**CCW IMPOUNDMENTS
INSPECTION REPORT**

**DAN RIVER STEAM STATION
ROCKINGHAM COUNTY,
NORTH CAROLINA**

**PROJECT No. 09-4157
SEPTEMBER 2009**

**CCW IMPOUNDMENT ASSESSMENT
DAN RIVER STEAM STATION
ROCKINGHAM COUNTY, NORTH CAROLINA
PROJECT NO. 09-4157**

PREPARED BY: <i>[Signature]</i>	DATE: 2-19-07	CHECKED: M.T.B.	DATE: 2-19-07	JOB NO. 6234-06-3908	FIGURE 8
---------------------------------	---------------	-----------------	---------------	----------------------	----------

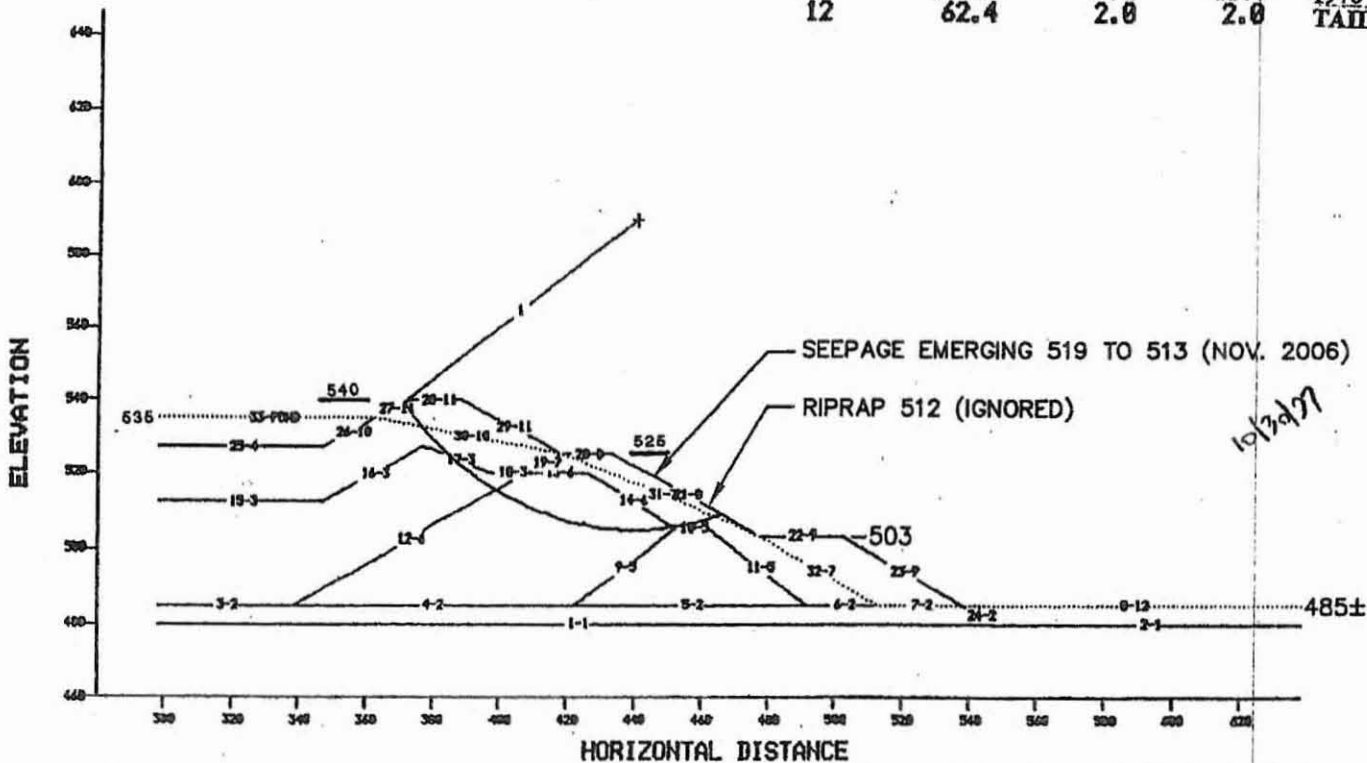
The 1997 analysis on Figure 8 showed a safety factor of 1.45 for deep failure surfaces in the downstream embankment, down from greater than 1.50 safety factor on comparable surfaces in the 1984-1985 analyses.

Photograph 8A

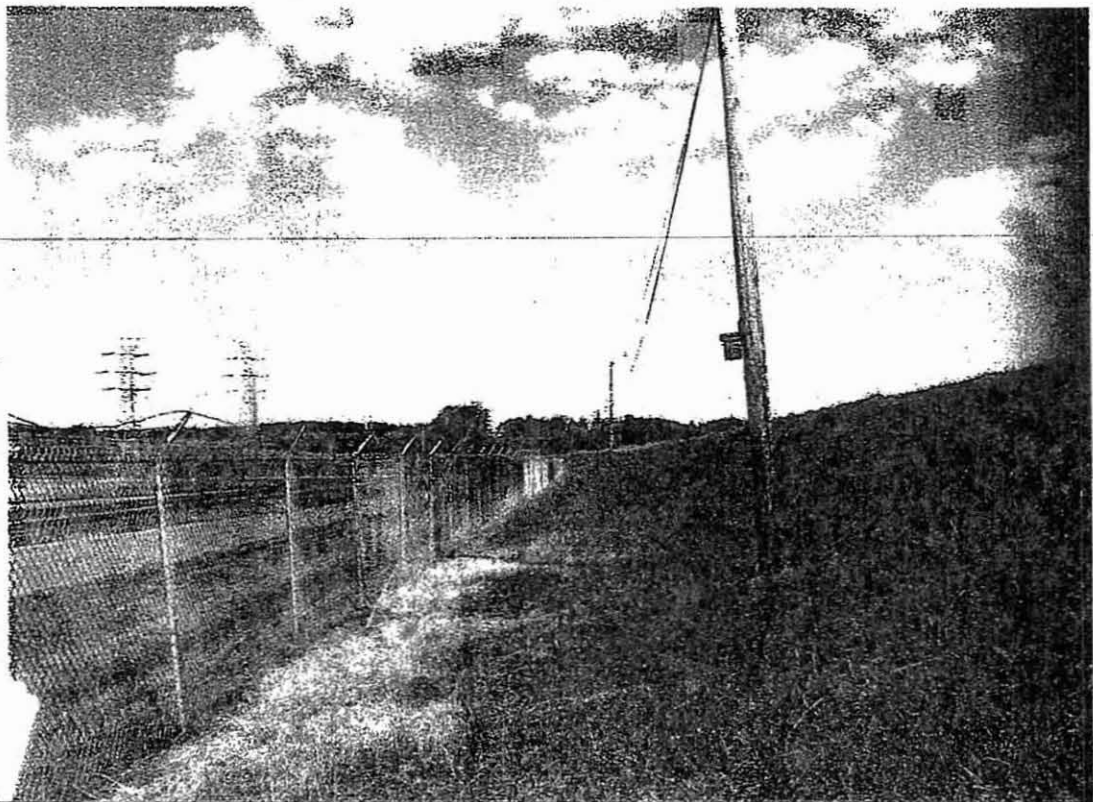
North dike, facing plant. Slope was wet above access road in 1996; was dry in 2001. Slope "notch" by access road maintenance in 1996, corrected by 2001, now reappears higher above road. Some seepage emerges at base of road slope.
